DEVELOPMENT APPLICATION ASSESSMENT REPORT

Application Number:	DA2021/2372
----------------------------	-------------

Responsible Officer:	Gareth David
Land to be developed (Address):	Lot 1 DP 124062, 56 Attunga Road NEWPORT NSW 2106
Proposed Development:	Alterations and additions to a dwelling house
Zoning:	C4 Environmental Living SP2 Infrastructure
Development Permissible:	Yes - Zone SP2 Infrastructure Yes - Zone C4 Environmental Living
Existing Use Rights:	No
Consent Authority:	Northern Beaches Council
Land and Environment Court Action:	No
Owner:	Timothy James Wearne Claire Lynne Wearne
Applicant:	Brooke Minto

Figure 2 - Proposed building envelope non-compliance on the western elevation (highlighted in green).

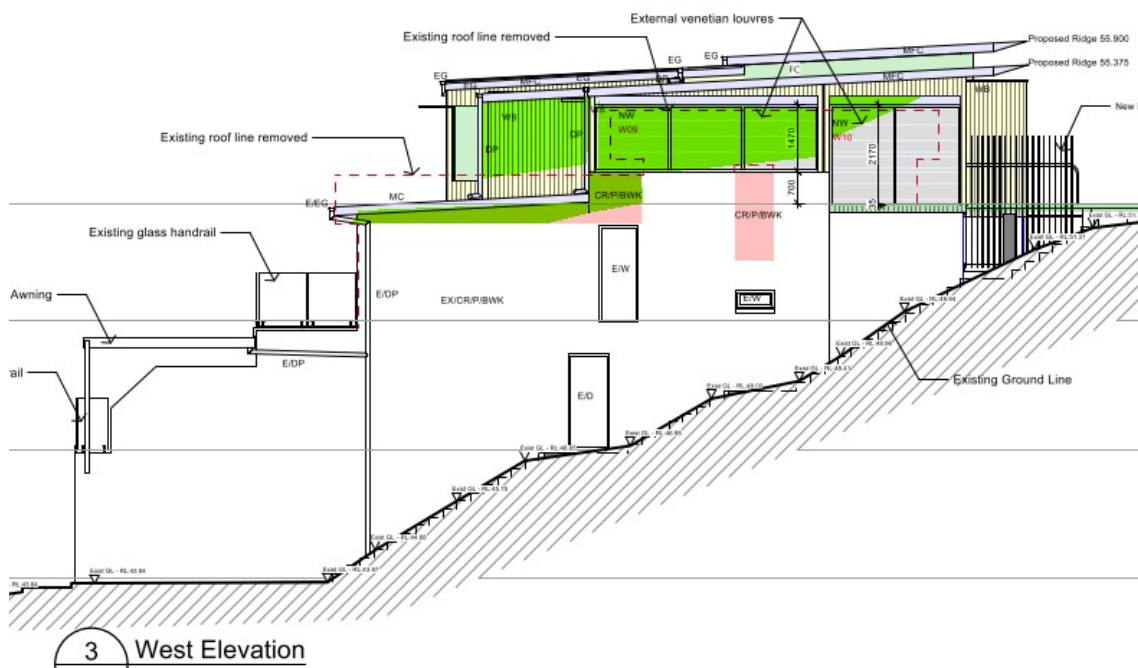
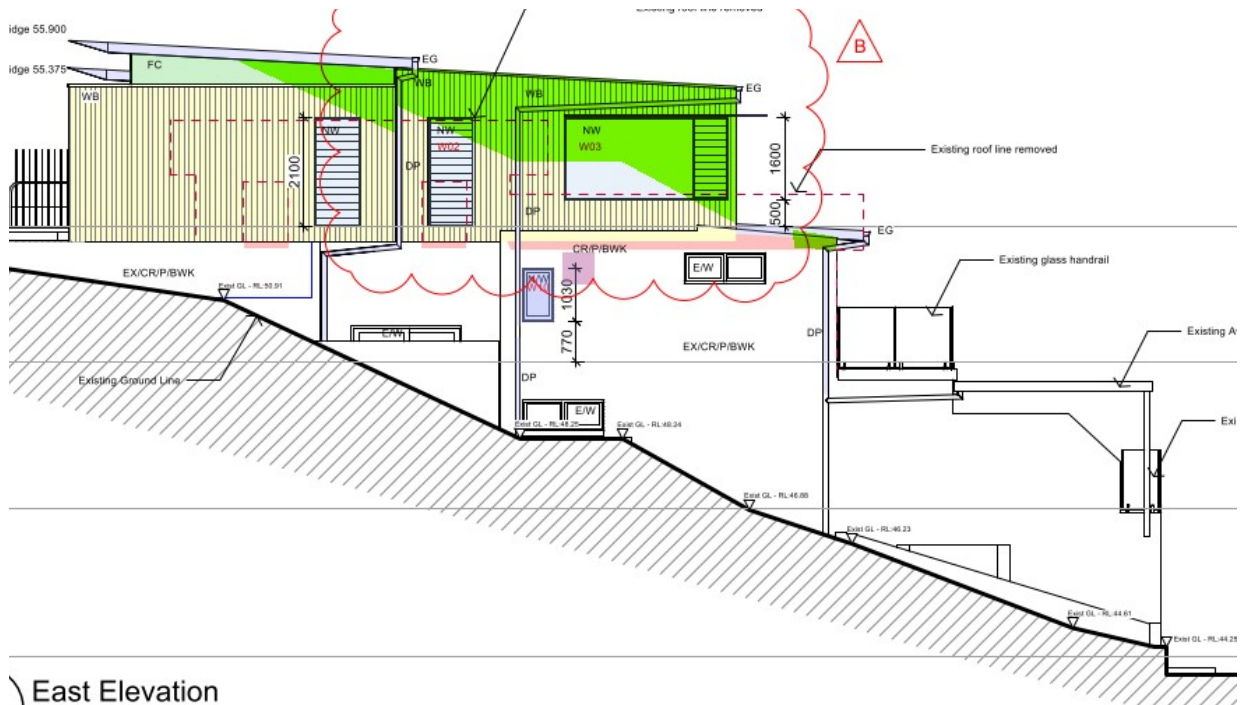
The proposed dwelling additions has a encroachment into the prescribed building envelope along the eastern and western elevations. This variation is represented in figures 1 and 2 below.

This building envelope non-compliance is partially attributed to the slope of the site, which exceeds 30% under the building footprint. P21DCP allows for a variation to the prescribed building envelope for development on steep sites, subject to consistency with the outcomes of this Clause. The building envelope non-compliance also partially arises due to the narrow nature of the site.
